Exhibit B - Preliminary Site Plan with Outdoor Storage

ARCHITECTURAL SITE PLAN

PROPOSED BUILDING FOR:
THE DICKMAN CO.
YAHARA RD
DEFOREST, WI

JOB:	223462
DRAWN:	NS
CHECKED:	DF
DATE:	2024-03-26
SHEET:	A0.3

1 ARCHITECTURAL SITE PLAN
1" = 40'-0"

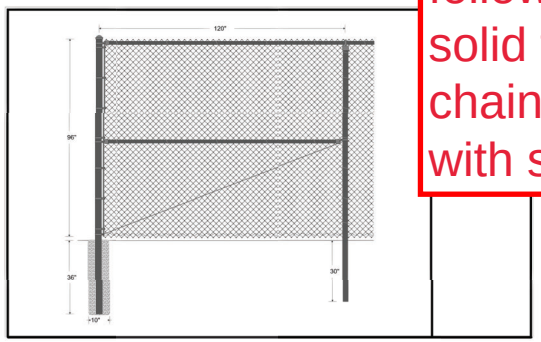
Add/adjust fence to follow red line as solid fence (not chain link, even if with slats or mesh)

Incorporate landscape buffering on outside of fence

Outdoor storage permitted in purple shaded area only
